File SPR-1996-080

Name: Orchard Lodge – E. of 28 1/4 Rd btw. Patterson /Orchard Ave. -Site Plan Review

FILE: #SPR-96-080  
DATE: April 18, 1996  
STAFF: Michael T. Drollinger  
REQUEST: Site Plan Review - Orchard Lodge  
LOCATION: W Side of 28 1/4 Road between Orchard Ave. & Patterson Road  
ZONING: RMF-16

**SITE, GRADING, AND DRAINAGE PLAN**

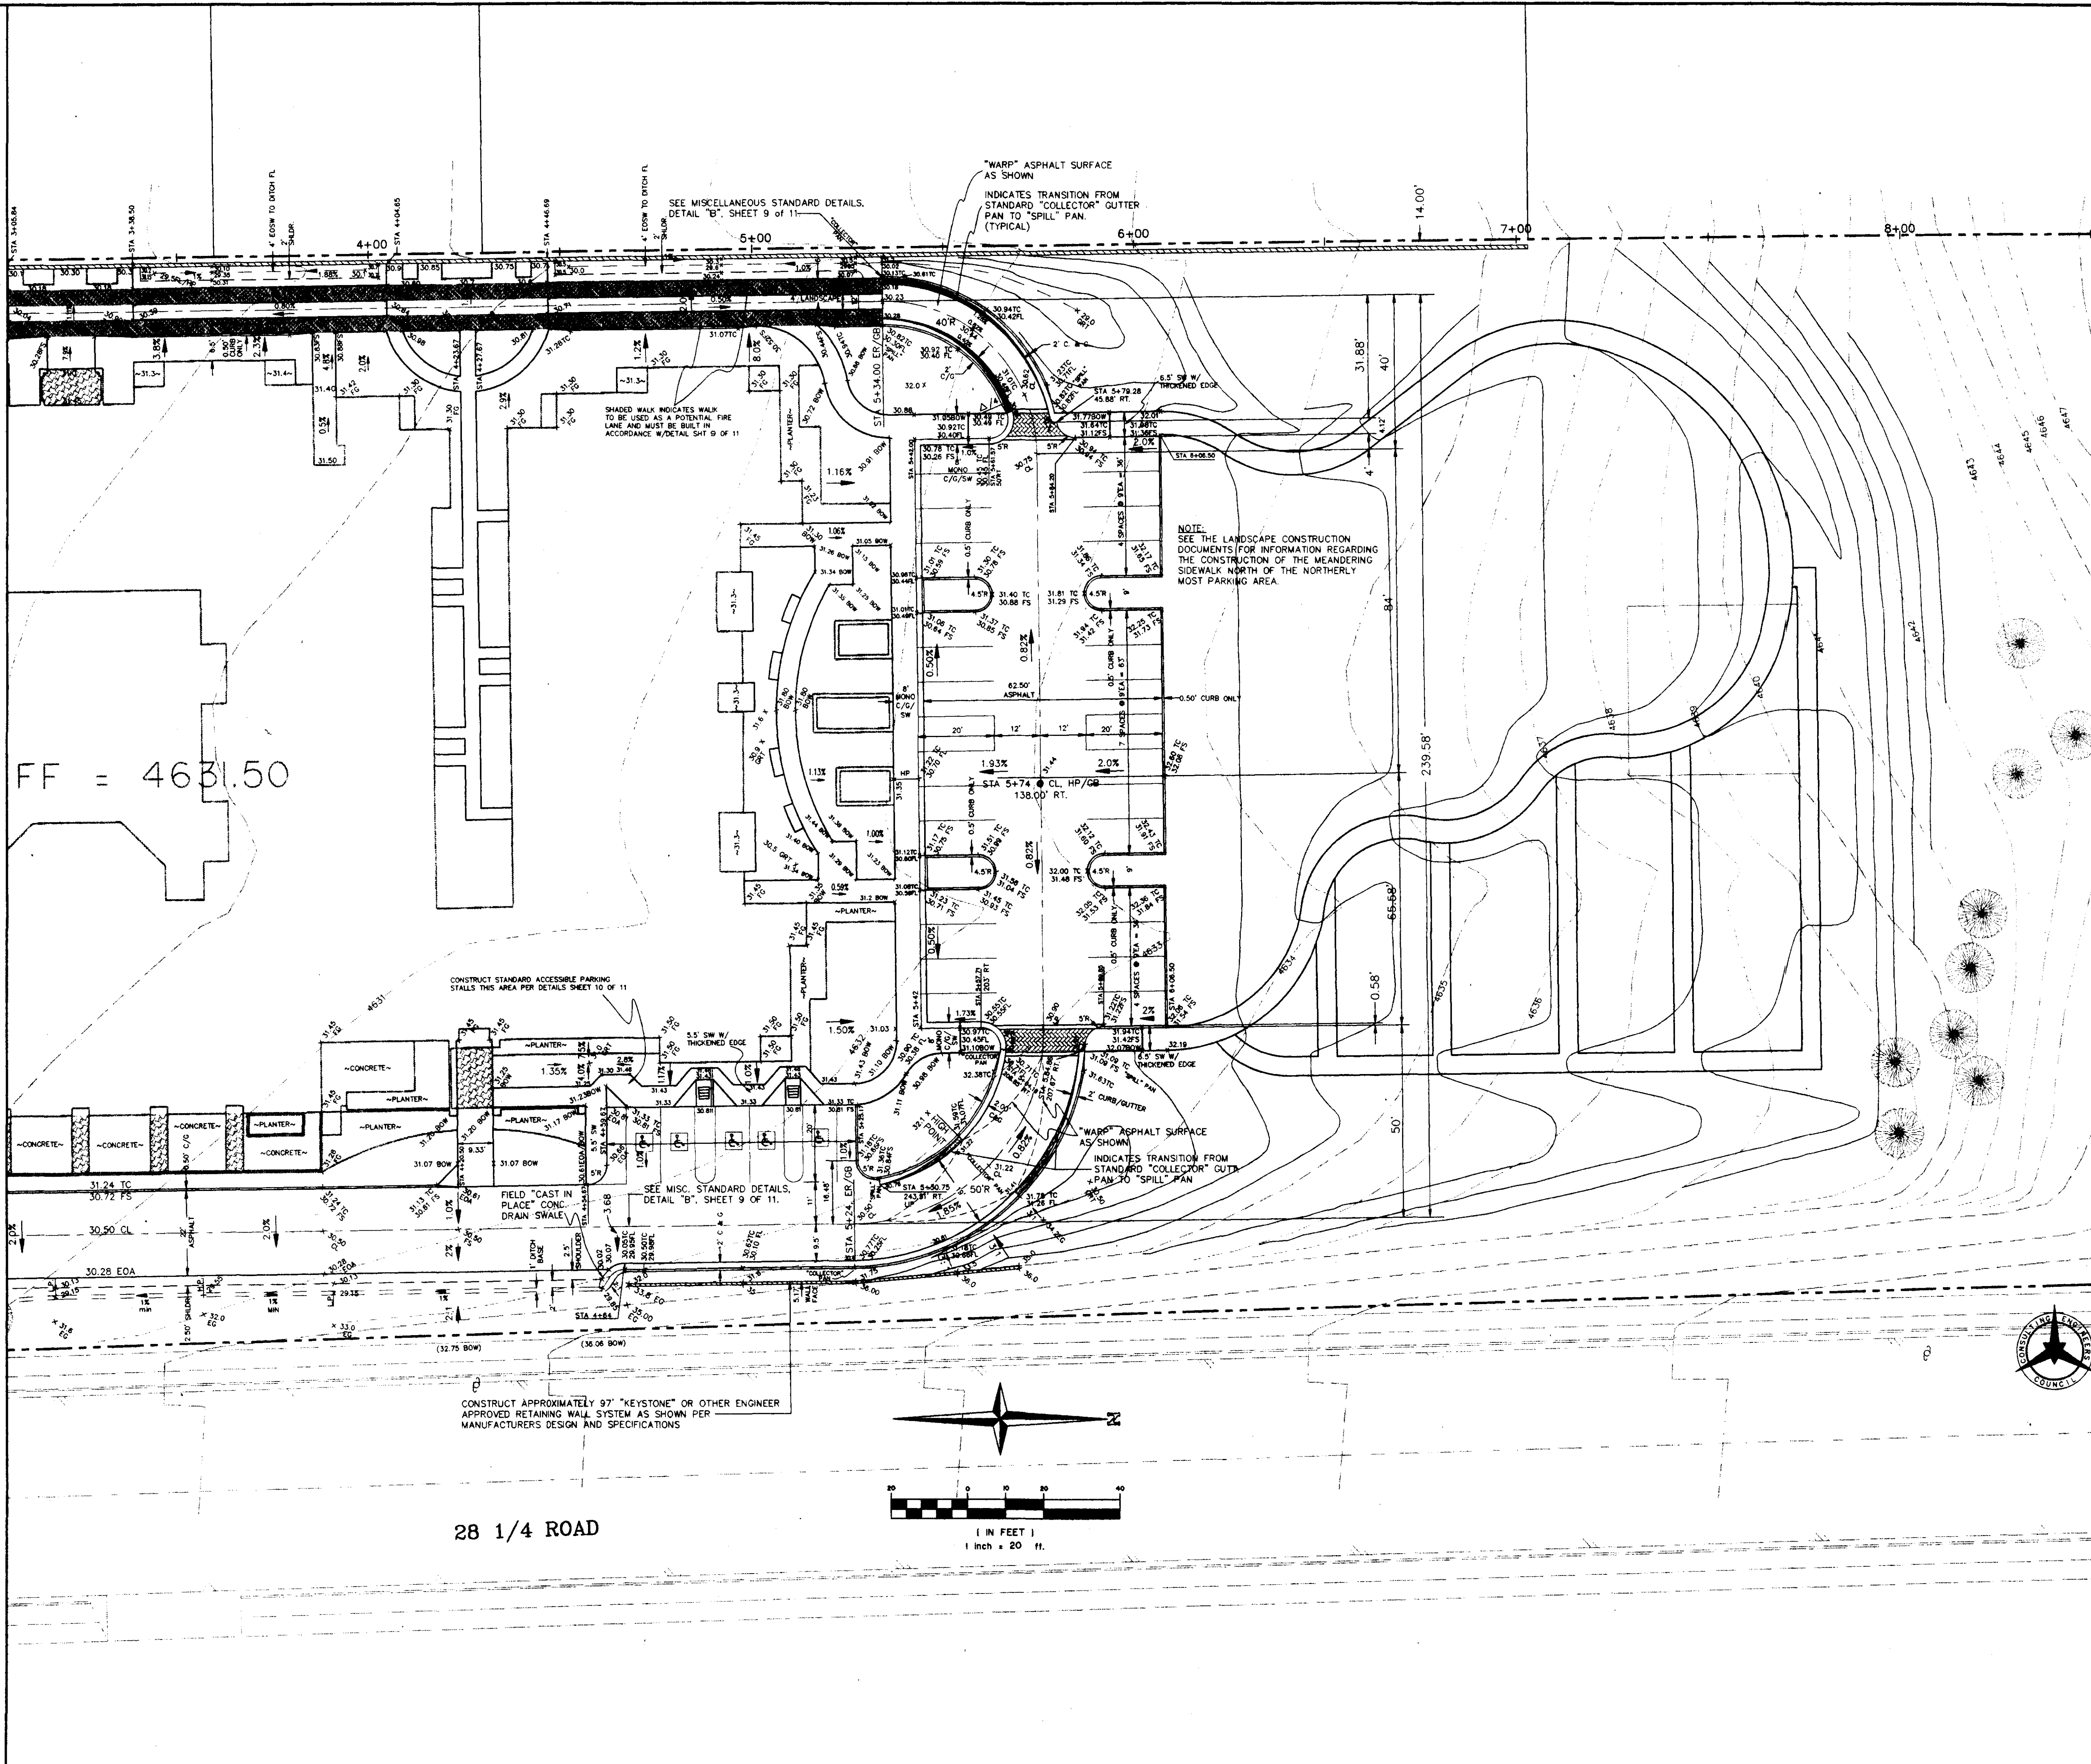
1. Grading and Drainage Plan drawings refer to "975 lf 8' masonry perimeter wall". City ZDC does not permit walls greater than 6 feet in height to be constructed within required building setback areas. Please lower wall height to six feet and provide a wall construction detail.
